SUNDRY NOTICES AND REPORTS ON WELLS

**Plugging and Abandonment Procedure  
Horseshoe Gallup Unit No. 9  
Attachment "A"**

Well: 9 Horseshoe Gallup Unit

WELL NAME 9 Horseshoe Gallup Unit  
 SEC, TWN, RNG. 30-31N-16W

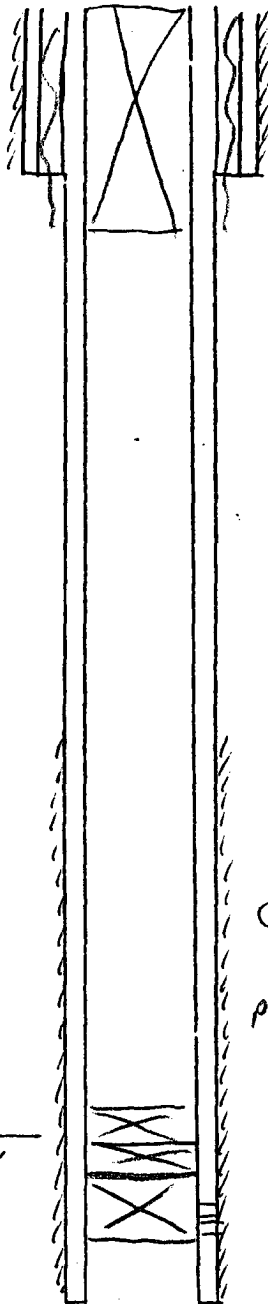
1. Plugging operations authorized are subject to the attached "General Requirements for Permanent Abandonment of Wells on Federal and Indian Lease."
2. Mike Flanikan with the Farmington Office is to be notified at least 24 hours before the plugging operations commence (505) 599-8907.
3. The following modifications to your plugging program are to be made:
  - a) Bring the top of the Gallup plug to 960'.
  - b) Place the Surface plug from 152' to surface inside and outside the 5 ½" casing.

- BLM geologist's pick for the top of the Gallup fm. reflects the top of the transitional Tocito interval in this well. This top varies from operator's pick in this well.
- It is recommended that the Gallup plug be extended upward to adequately isolate the Gallup top identified in this report.

152 = Surface w 50 SKS

$$152 / 7.299 (1.18) = 18 \text{ SKS}$$

$$50 / 5.7719 (1.18) = 7 \text{ SKS}$$

$$102 / 5.192 (1.18) = 17 \text{ SKS}$$

$$(1210 - 960) + 50 / 7.299 (1.18) = 35 \text{ SKS or greater}$$

plug 1210 - 960
